## Investigation Summary Report Update 3

Date: 12 December 2017

This investigation is into the activities of heavy vehicle specialist certifier Peter Wastney and was initiated following a crash on 27 August 2017, where the catastrophic failure of a drawbeam on a truck JWN197 resulted in the detached trailer travelling a significant distance before coming to rest against a bank.

Figure 17 Side plate fatigue progression and initiation point (red circle)

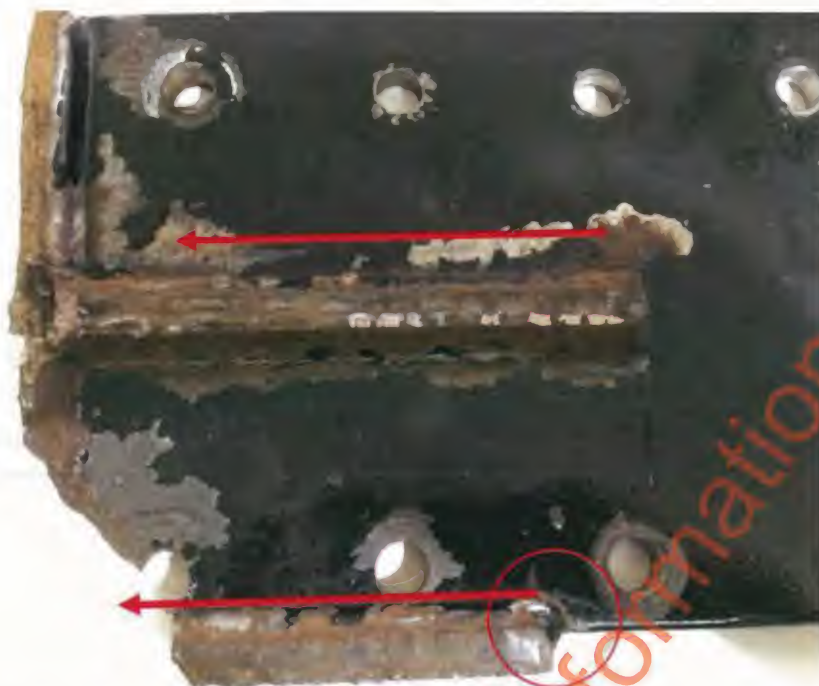
Evidence of fatigue in the drawbeam weldment was found (Figure 17). The fracture between the upper and lower stiffeners and side plate has occurred at the base of the weld toe in the parent metal; this is a typical area for crack initiation and propagation (Hobbacher, 2006). The crack initiation point seems to be located at the rear bottom stiffener plate, refer Figure 17 and Figure 18.

Figure 31 von Mises stress, drawbeam 260kN load, areas in grey exceed 250 MPa

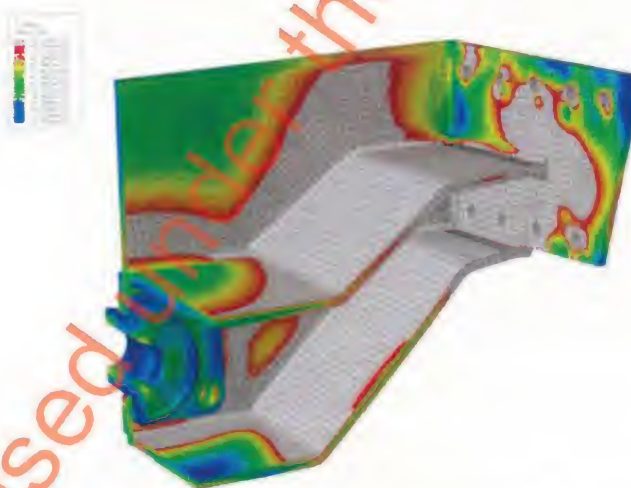
A 260kN load (for a 30,000kg MTM trailer) is applied to the Ringfeder attachment. The applied load caused large areas of the drawbeam to exceed the material yield stress, Figure 31.

The drawbeam does not comply with the requirements of NZS 5446 for static longitudinal loading. The stress in the drawbeam should not exceed 150 MPa and or show any yielding (plasticity).

Figure 32 von Mises stress, drawbeam 260kN load, areas in grey exceed 150 MPa

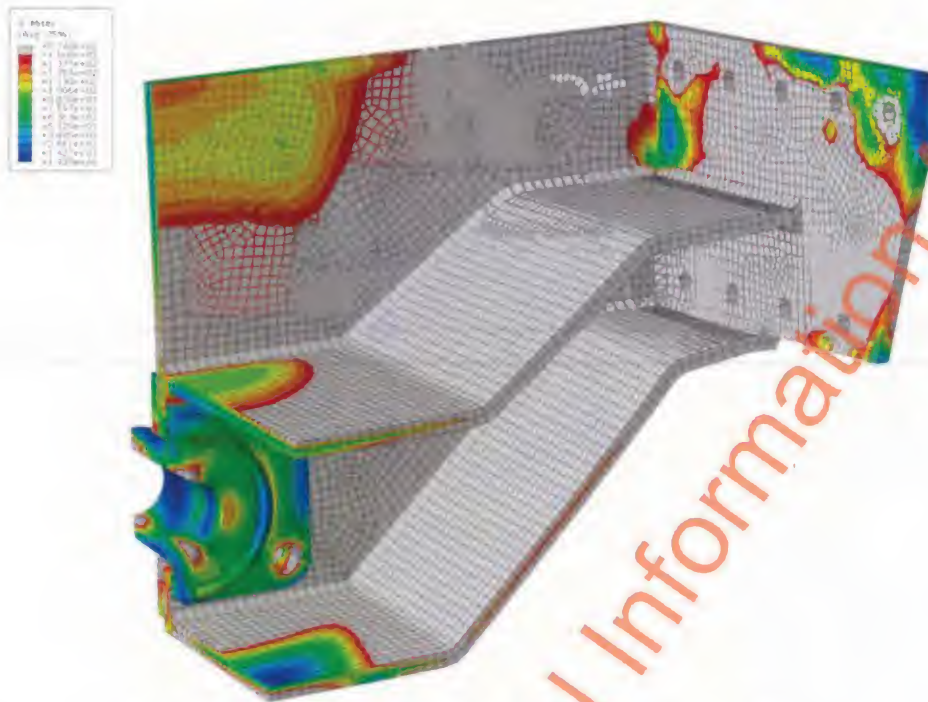
Large areas also exceed the maximum permissible stress of 150 MPa, Figure 32.

Figure 33 Areas showing plasticity after removal of load (colour other than indicator)

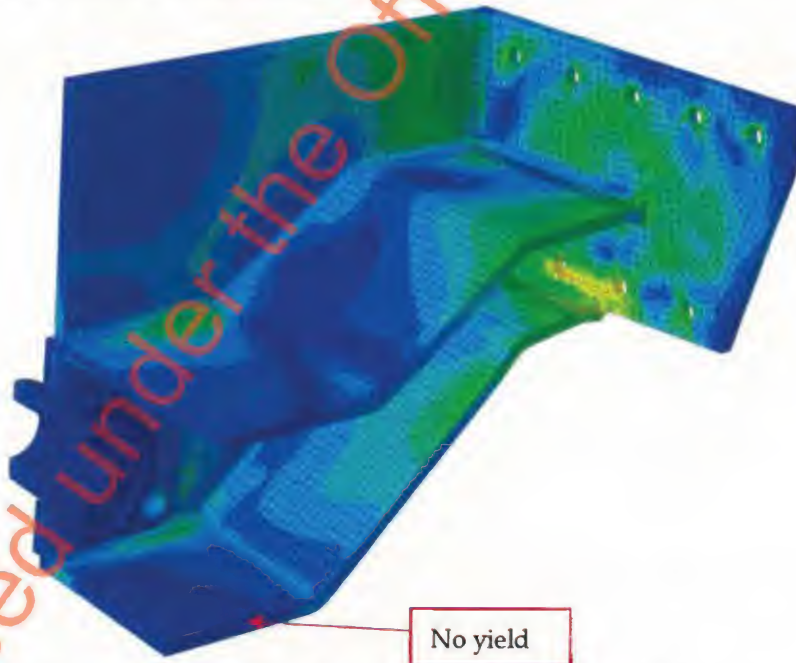
After load removal, the finite element analysis showed areas of the drawbeam had permanent deformation (plastic yield).

Figure 39 Forward (tension) direction 110kN load, 265 MPa red circle

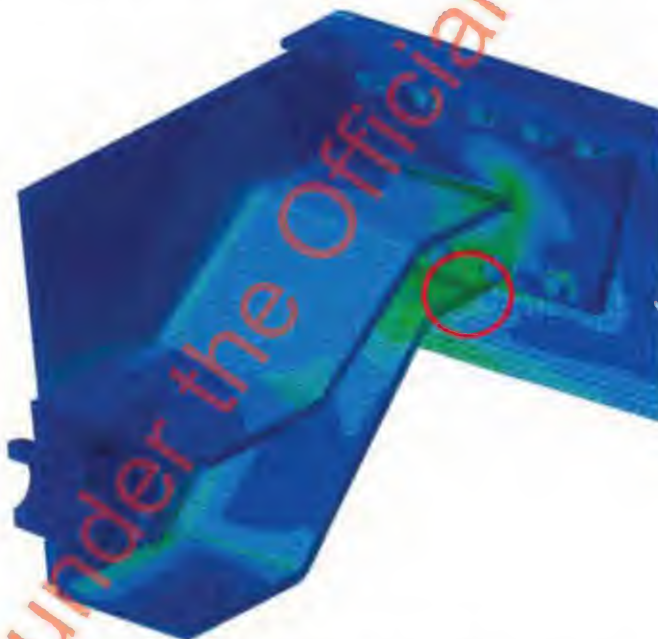
The stress in the drawbeam with the load in the forward direction, at the bottom flange to side plate rear connection, was 265 MPa of compressive stress, Figure 39.

Figure 41 Rearward (compressive) 110kN load, 274 MPa

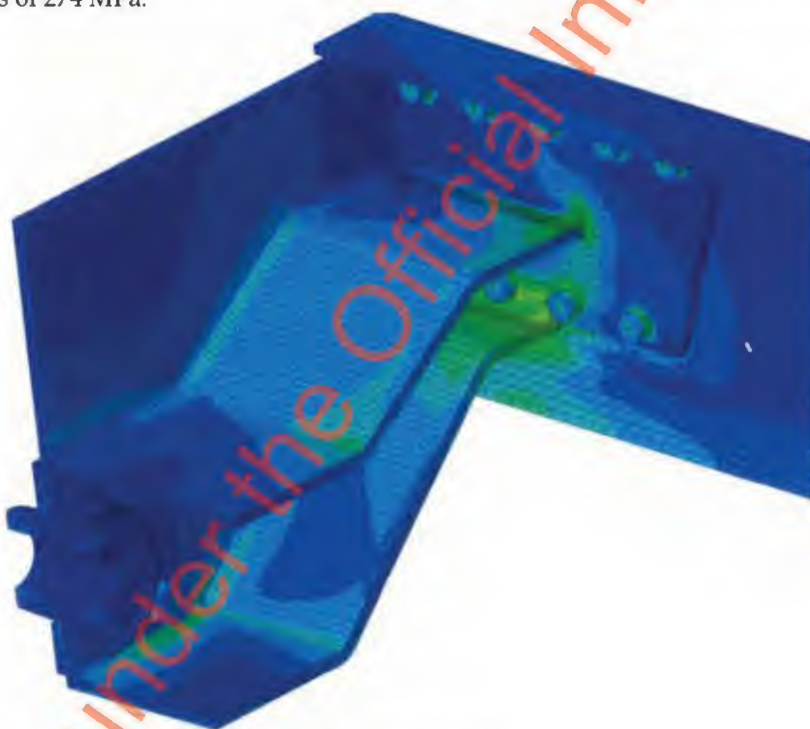
Under compressive load, the connection of interest is under tension and has a developed stress of 274 MPa.

Figure 43 Certifiers drawbeam analysis - 220kN

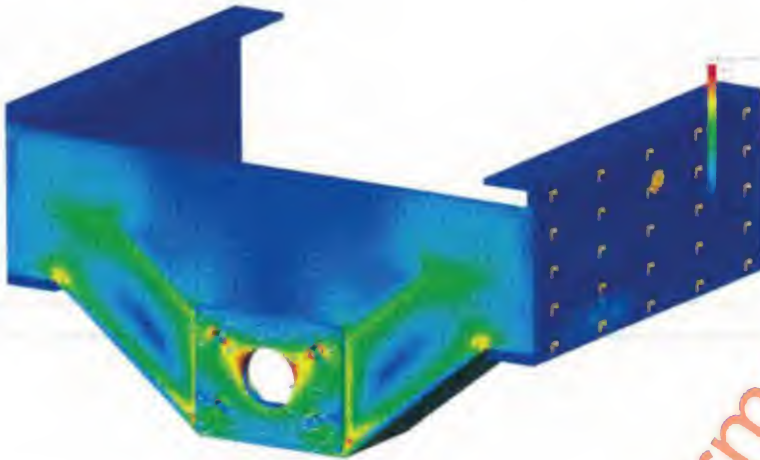
It is notable that the certifiers FEA results show stress levels which significantly exceed the material yield stress. The certifiers model shows the drawbeam does not comply.

Figure 44 Certifiers drawbeam analysis - 220kN, rear view

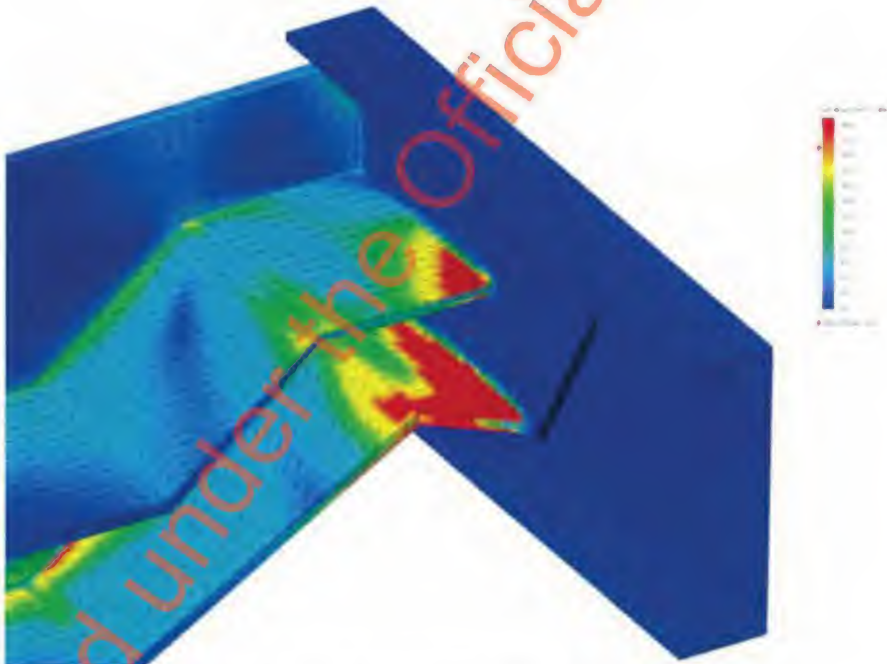
Refinement of the finite element mesh was carried out in order to improve the accuracy of the results; this is good practice. Mesh improvement and convergence studies are an important part of validating FEA.

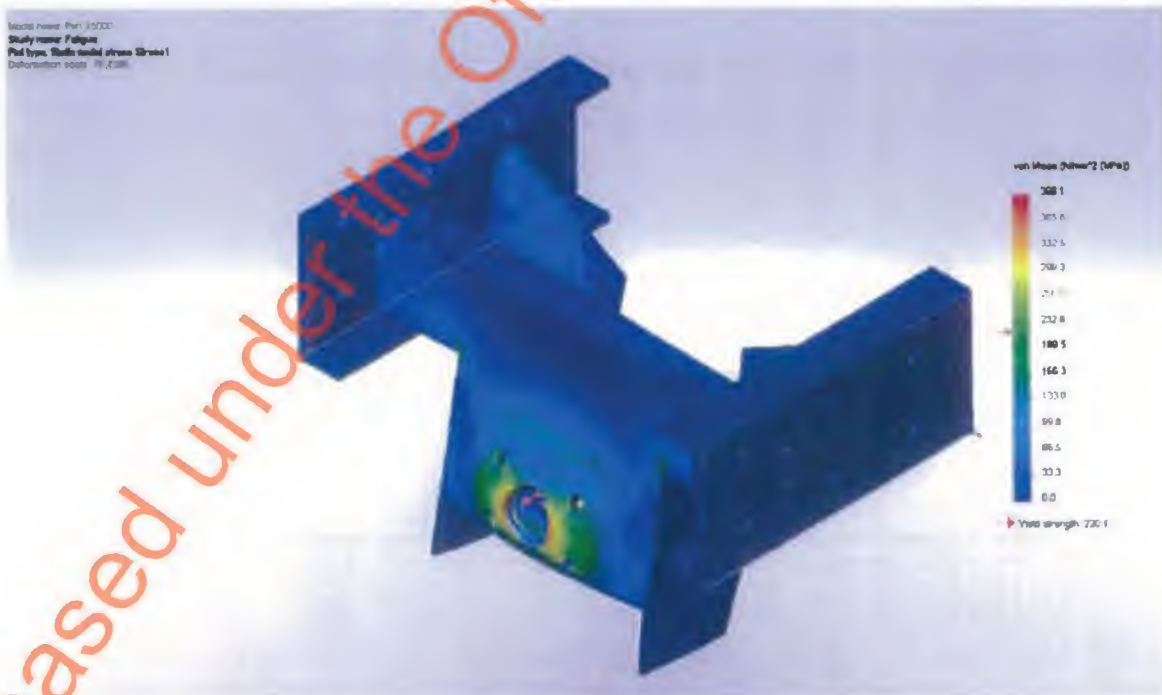
The information provided to support your certification decision is inadequate; on what basis did you determine that the drawbeam meets NZS 5446?

In particular the image below is from your certification file for LT400 348824. For fatigue compliance stress should be no more than 60% of yield strength according to AS 3990, however the FEA image shows stress levels above yield. Is this correct, and if so why did you proceed to certify the drawbeam?

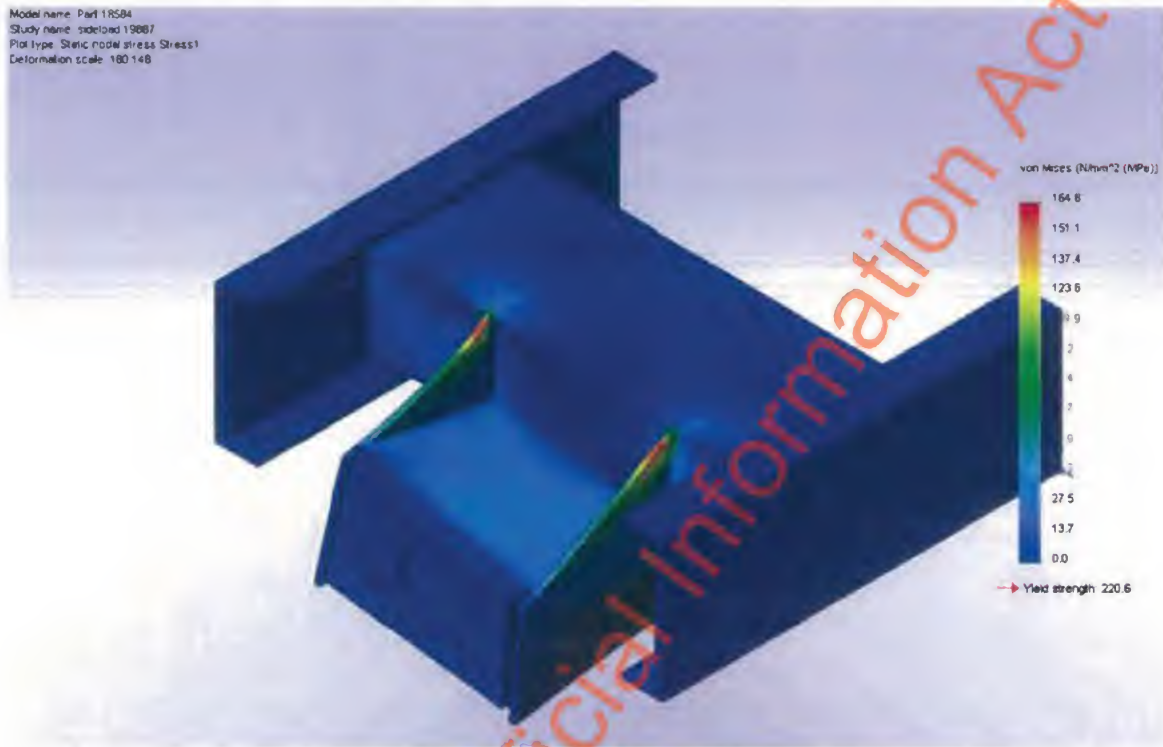
In particular the image below is from your certification file for LT400 607095. For fatigue compliance stress should be no more than 60% of yield strength according to AS 3990. For a yield strength of 220MPa that would be 132MPa, however the FEA image shows stress levels above this – in the region of 150MPa. Is this correct, and if so why did you proceed to certify the drawbeam?

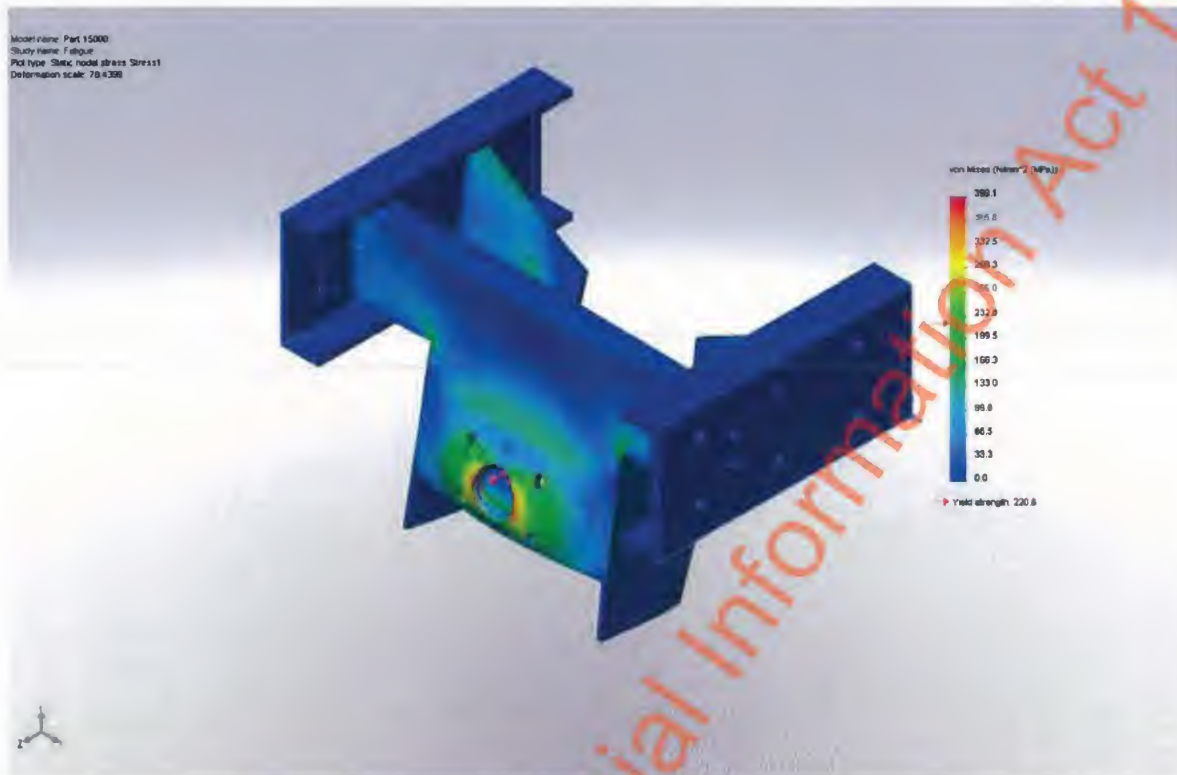
No Bolt Load Analysis.

Bolt Load analysis is held on a separate Excel file to the main certification documents supplied to you, and was not included. This analysis is now attached.

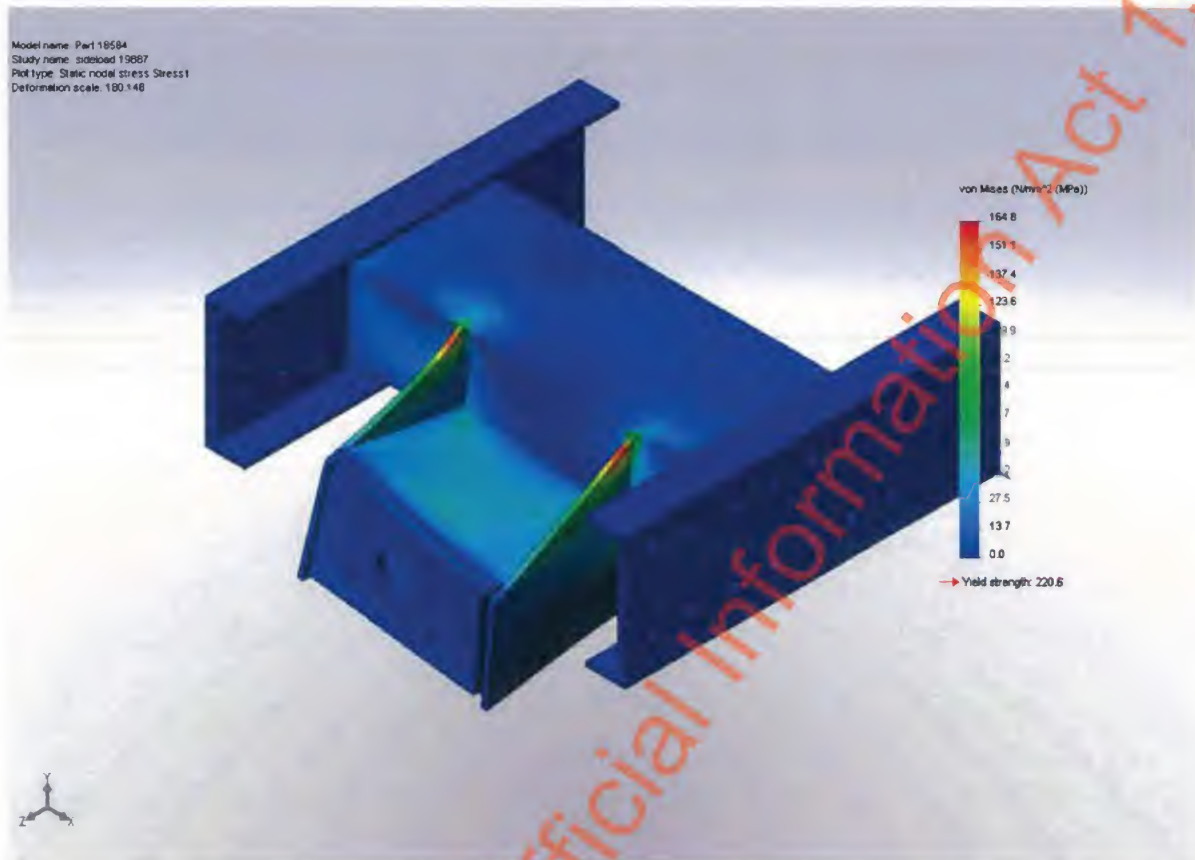
You raised the query on the Side Load Analysis on the above drawbeam, noting in the attached Diagram that the analysed stress was 165 mPa, higher than the 60% of yield for 220 mPa material.

This was in small surface areas of the Gussets. Although the analysis was carried out for 220 mPa yield, manufacture for this new drawbeam was from 300 mPa Yield plate, so this design was accepted as being within the allowable limits.

Figure 2 Drawbeam design 17452, Isometric view (left), Isometric view rear (right)

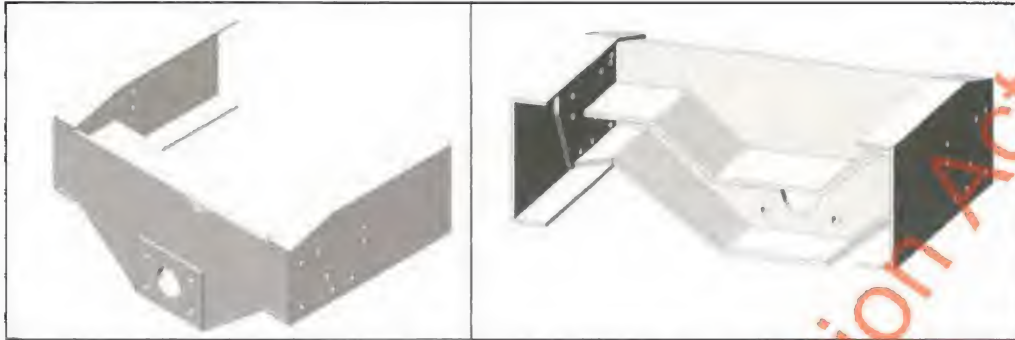
The drawbeam was certified on [REDACTED] in January 2016 before being replaced due to failure after approximately 40,000km of service on the 8<sup>th</sup> of December 2016. The total approximate service life of the drawbeam is 79,000km.

Overlaying the SolidWorks CAD files shows that both drawbeam designs, 17542 and 18877, are identical. The only differences are in the truck chassis dimensions and the bolt group detail. The SolidWorks stamp dates and suppressed features in the SolidWorks model tree also support this conclusion, Figure 4 and Figure 5.
